Hope Creek Generating Station
Facility Operating License No. NPF-57
NRC Docket No. 50-354

Subject: Response to Request for Additional Information
Request for License Amendment - Extended Power Uprate

Extended Power Uprate Response to Request for Additional Information

Figure RAI14.79.8b. Comparison of the real (left side) and imaginary (right side) components of the stress intensity distribution at 101.4 Hz on Mesh x1 (top), Mesh x2 (middle), and Mesh x4 (bottom).

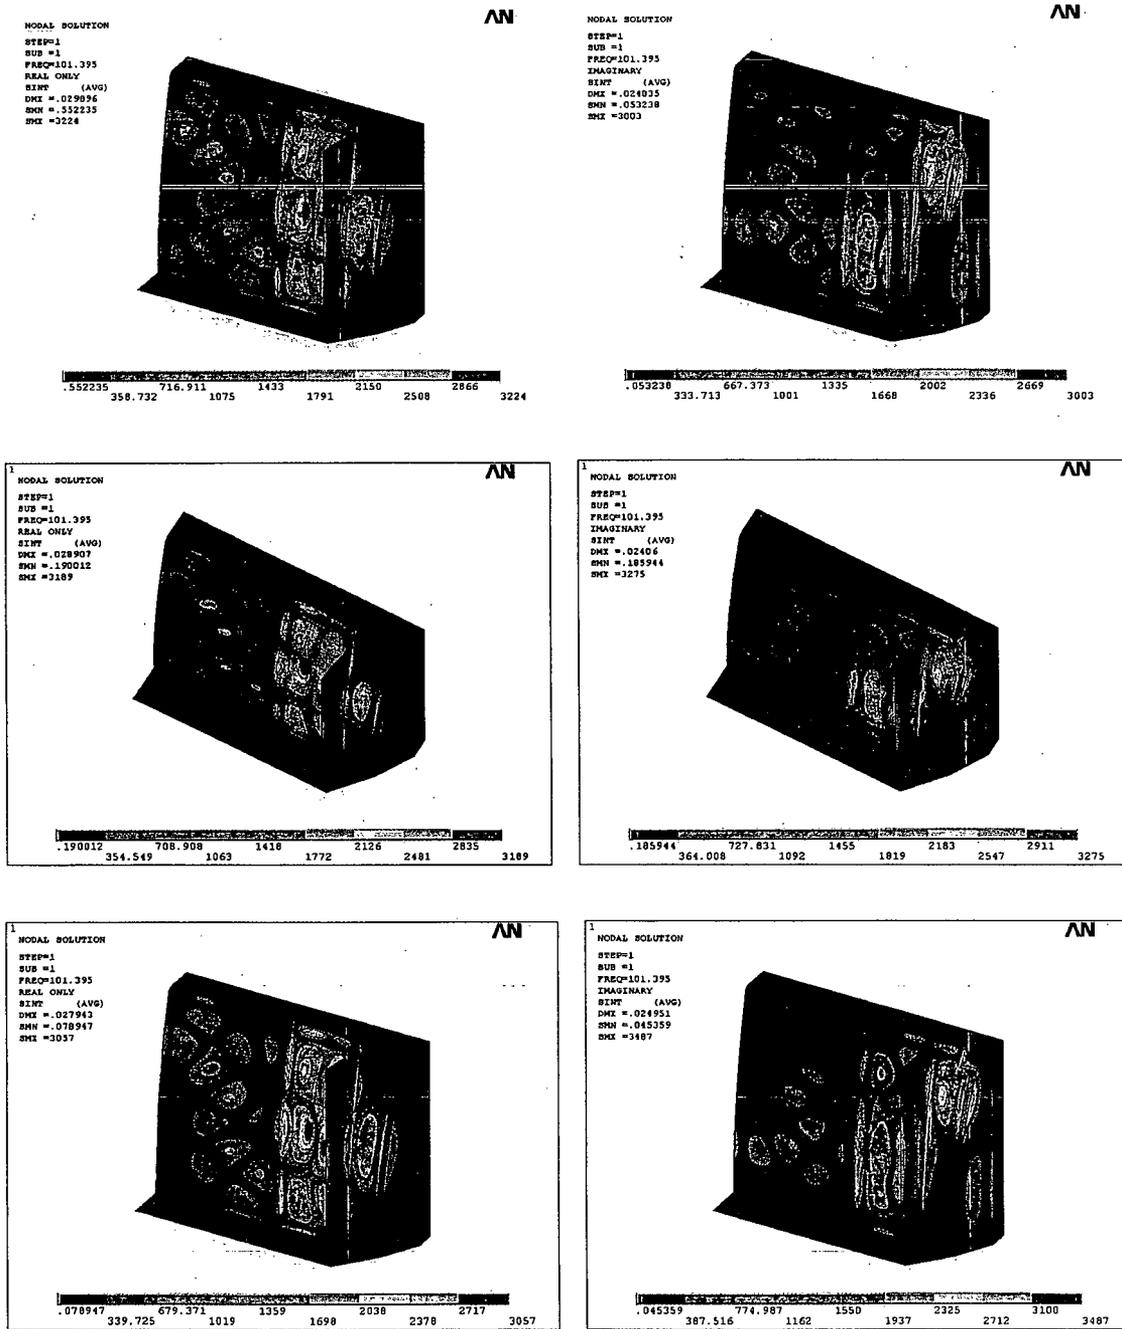
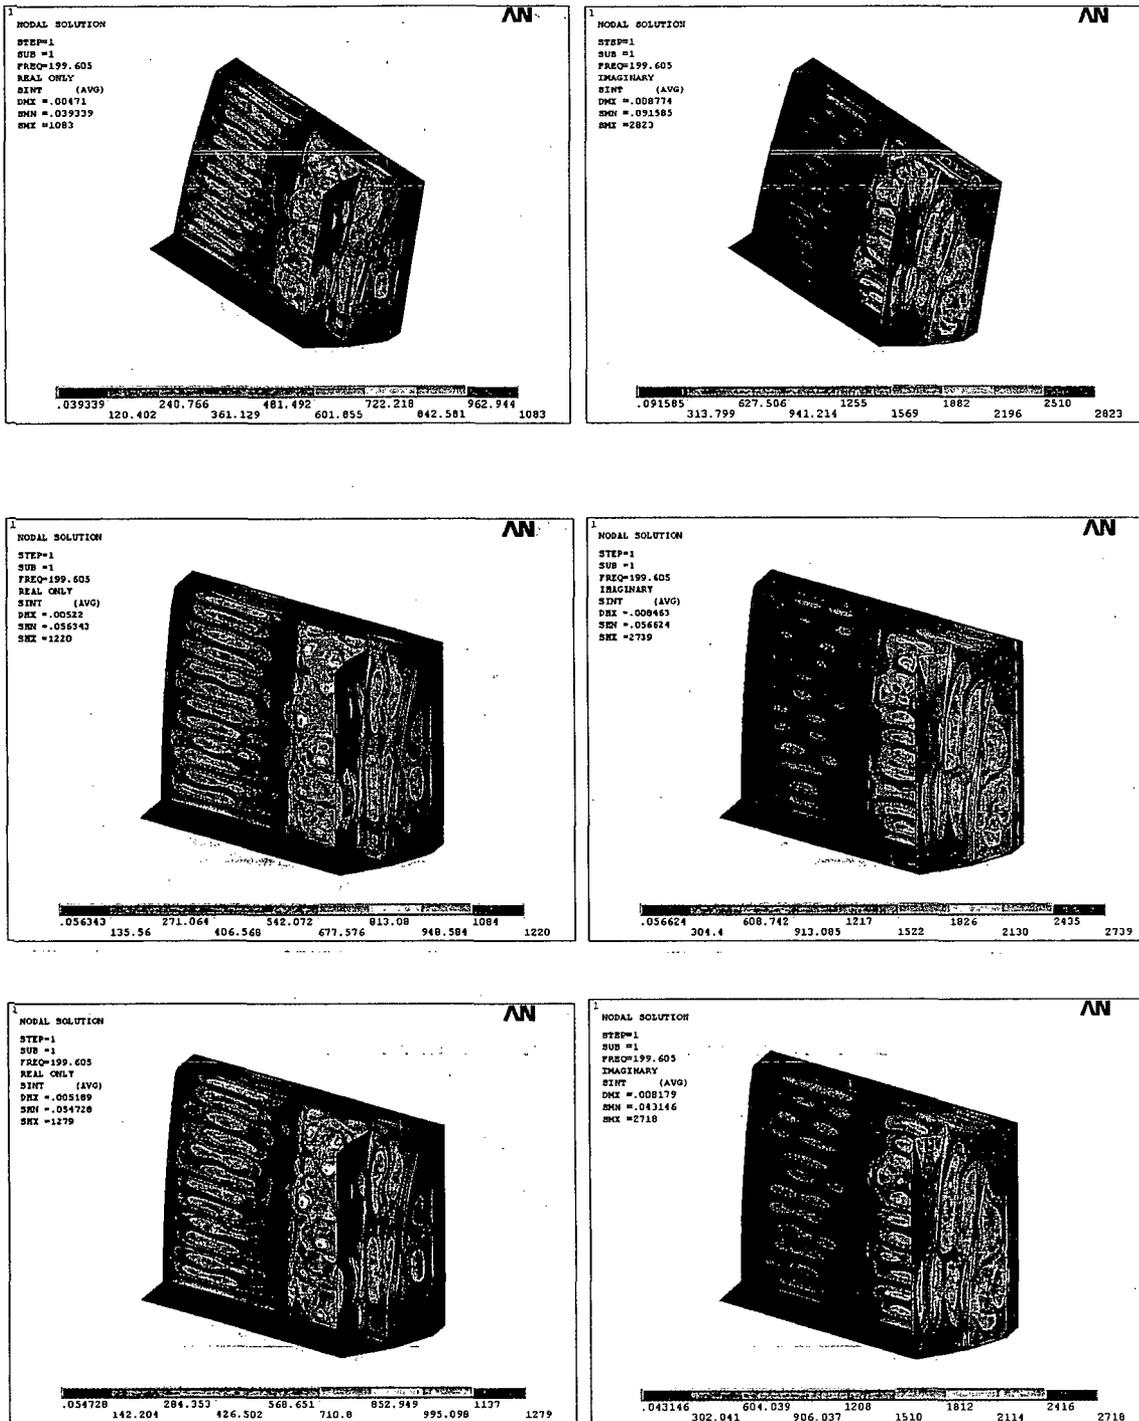
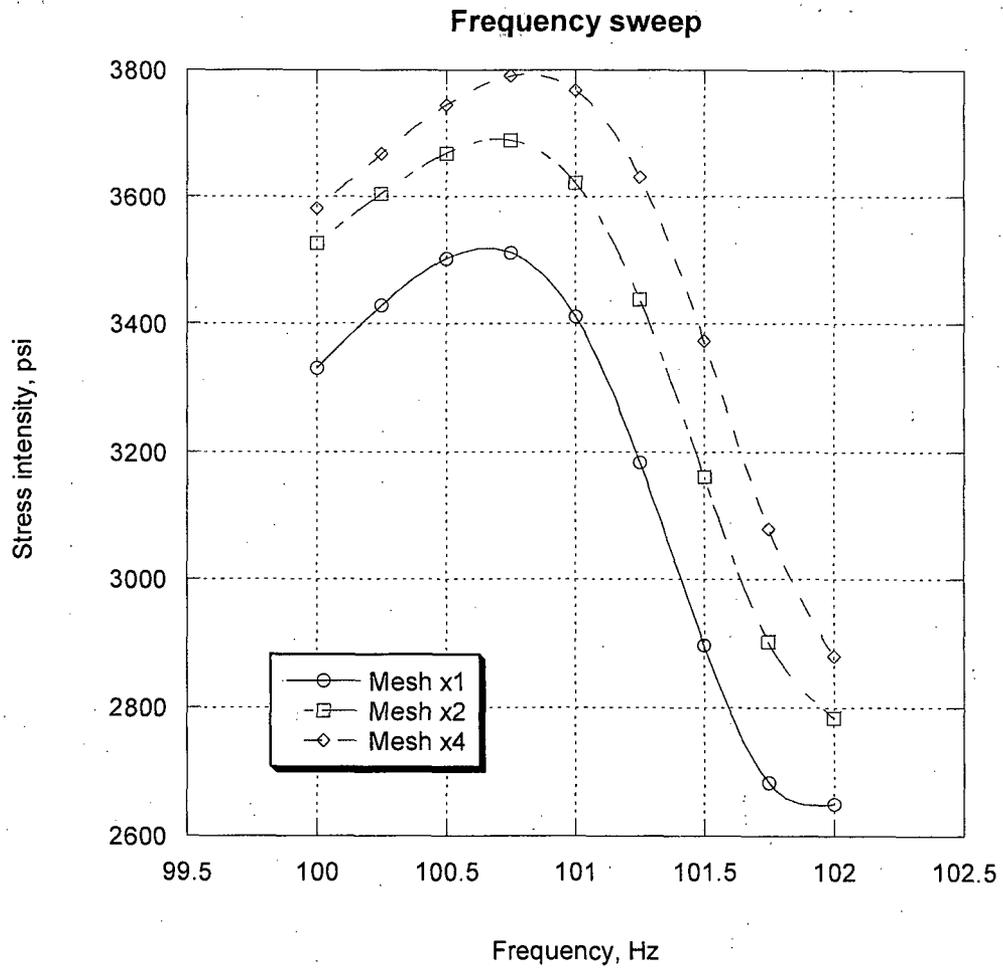
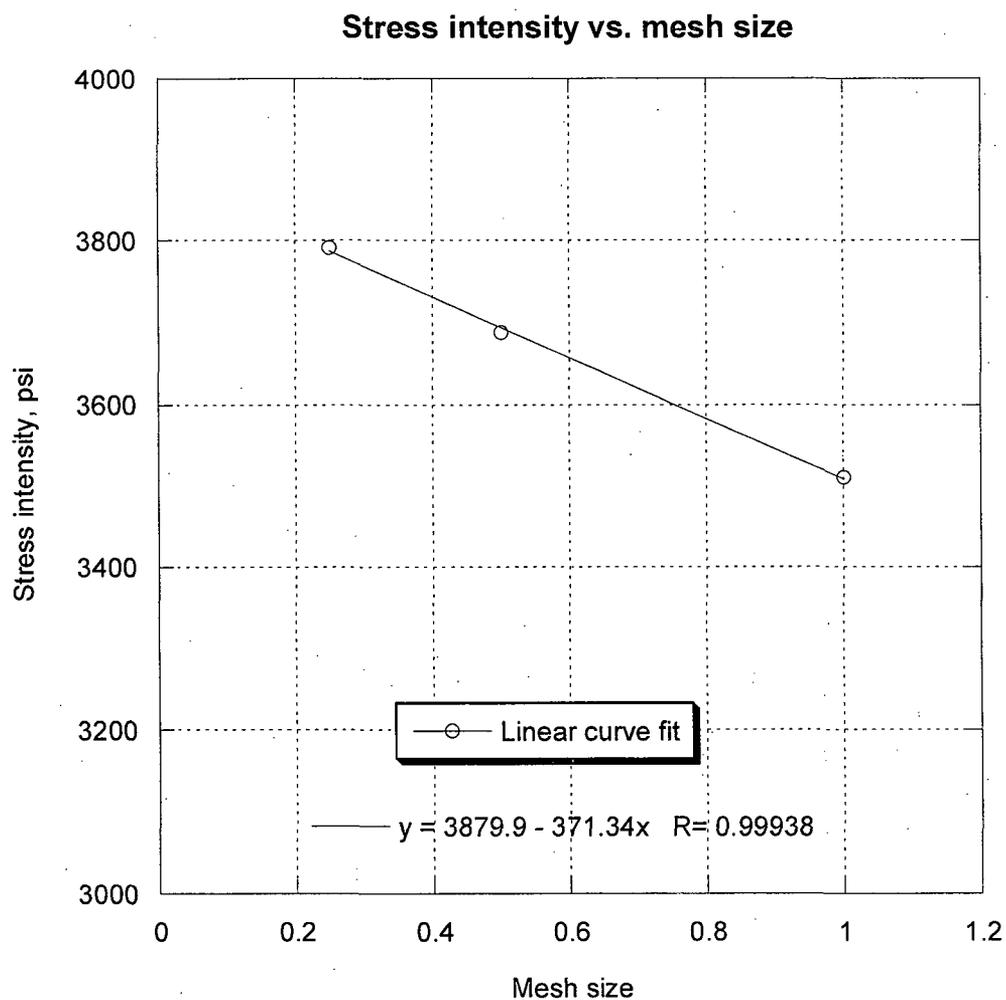
In response to RAI 14.79 and in Section 3.8, *Mesh Details and Element Types*, of CDI Report No. 07-17P, PSEG describes numerical experiments carried out using the ANSYS code applied to simple analytically tractable structures with dimensions and mesh spacing similar to the ones used for the steam dryer, confirming that the natural frequencies are accurately recovered (less than 1 percent errors for the first modes). The staff noted that establishing convergence of resonance frequencies is not sufficient to establish convergence of strain and stress fields. Also, frequency shifting loading functions does not account for lack of convergence in strain and stress fields. Therefore, as a follow-up to RAI 14.79, PSEG is requested to provide pertinent parametric evaluations related to mesh convergence in high strain and stress regions in the Hope Creek steam dryer to assess whether the dimensions and mesh spacing used for the model are adequate. In particular, plots of stresses near high stress regions for coarse and dense FE meshes could be used to confirm that the dryer model used to establish the Hope Creek limit curves are converged.

Mesh refinement tests were conducted on a structure excised from the Hope Creek Unit 1 steam dryer comprising the middle hood with two hood supports, side plate, cover plates and closure plate as shown in Figure RAI14.79.1. All dimensions and structural properties were kept the same as in the full model. Structural damping was prescribed at 1% of critical at all frequencies. Cantilevered supports were introduced at the edges typically coupled to heavier parts of the steam dryer such as the upper support ring and vane bank.

To investigate the mesh dependence of stresses and displacements, three different grids were considered. The coarsest mesh, labeled Mesh x1, is representative of the mesh sizing used in the full steam dryer calculation (see top figure of Figure RAI14.79.2a) and contains 4329 nodes and 4208 elements. A finer mesh, denoted by Mesh x2 and containing 11914 nodes and 11726 elements, is obtained by uniformly

The typical convergence behavior for the maximum stress intensity during adaptive mesh refinement is shown in Figure RAI14.79.3, where the horizontal scale ("Iteration Number") is the number of adaptive mesh refinement steps. The results of adaptive refinement for all three initial grids are summarized in Table RAI14.79.1. The calculated stresses did not change appreciably during adaptive local mesh refinement. Overall, the range of computed stress intensity values is within 4% of stress intensity values computed on Mesh x1. The deflected shapes and stress intensity distributions are shown in Figure RAI14.79.4. These results show that the static solution is indeed satisfactorily converged on the grid Mesh x1.

To investigate the reason for this discrepancy, additional calculations were undertaken over the 100 – 102 Hz frequency range in 0.25 Hz increments, and the amplitude at Location 2 was computed. The results are summarized in Figure RAI14.79.9 and show that at 101.4 Hz the frequency response is changing rapidly and that the 15.8% variation can be attributed to the slight shift in the frequency response on different meshes. Thus, rather than comparing the stress intensities at a fixed frequency, it is more useful to compare the maximum stress intensity amplitudes on each mesh. This comprises a more relevant comparison, since these maxima in the stress intensity frequency responses correspond directly to the values tabulated in the full steam dryer stress reports (and, consequently, also the stress ratios). From Figure RAI14.79.9, the peak response on all meshes occurs at 100.75 Hz. The associated peak stress amplitudes are plotted versus mesh size in Figure RAI14.79.10. The actual values are 3510.4 psi on Mesh x1, 3688.5 psi on Mesh x2, and 3790.8 psi on Mesh x4. In Figure RAI14.79.10 the mesh size is normalized by the average element size of Mesh x1; hence the normalized mesh sizes of Mesh x1, Mesh x2, and Mesh x3 are 1.0, 0.5, and 0.25, respectively. It may be seen that computed peak stresses adhere closely to a linear dependence on mesh size. Therefore, one can fit the available values and reliably extrapolate to estimate the stress peak at infinite mesh resolution (i.e., mesh size = 0). From the equation of the linear fit, shown on Figure RAI14.79.10, the best estimate of stress intensity at the peak is 3880 psi. This implies that the error in the coarsest Mesh x1 peak stress prediction (of 3510.4 psi) is $(3510.4 - 3880.0)/3880.0 = 9.53\%$.

In conclusion, a grid with element size typical of Mesh x1, which is representative of that used in the full steam dryer evaluation, incurs errors in the peak stresses that are less than 10%.

Figure RAI14.107.1. MatLab comparison between an unfiltered signal (blue curve) and a narrow filtered signal (green curve) around 120 Hz.

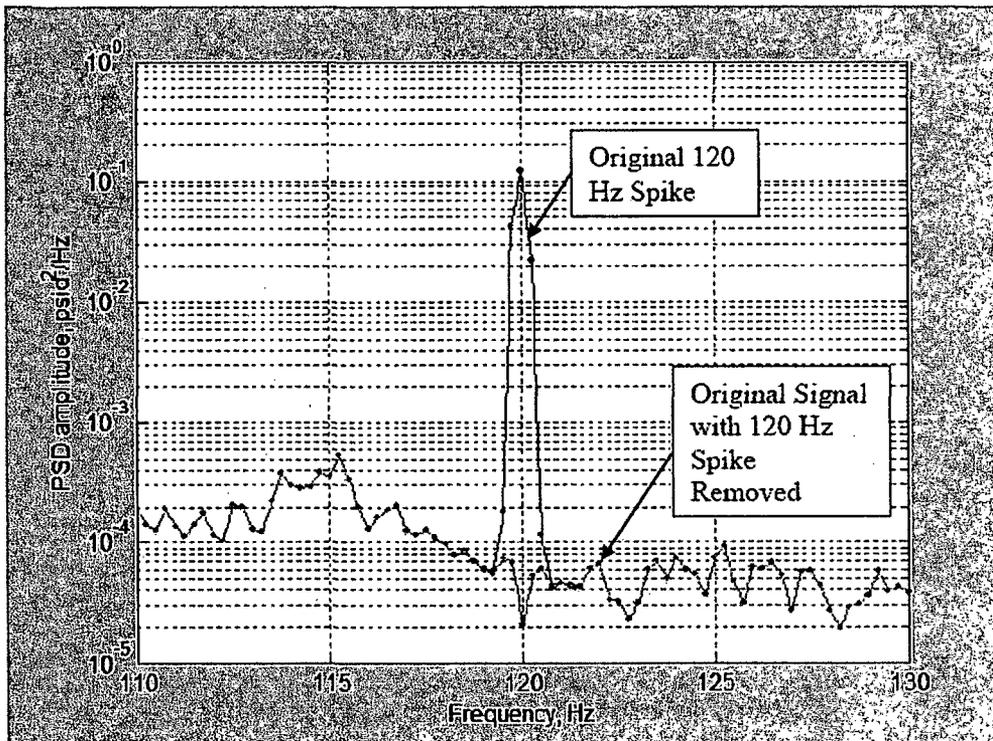
The projected Hope Creek MSL pressure spectra provided in response to RAI 14.107 show that tones may appear near 120 Hz. Since PSEG currently filters 120 Hz signals from the MSL measurements, explain the monitoring and calculation of stress effects of any valve singing tone that occurs near 120 Hz.

The anticipated standpipe excitation frequency is 118 Hz. Electrical noise exhibits itself in the main steam line pressure data as narrow spikes centered on 60, 120, and 180 Hz shown by the blue curve in Figure RAI14.107.1. When these frequency spikes are processed by a MatLab function that uses a second-order stop-band Butterworth filter, the original signal is not affected outside of a frequency width of ± 1.0 Hz.

⁽³⁾] A sample of this raw data from main steam line A is shown in Figure 14.107-2. It would be difficult for this feature to mask a flow induced vibration signal, which has a frequency width that is typically three or four times wider based on industry experience. See for instance C.D.I. Report No. 07-09P, Figure 6.1.
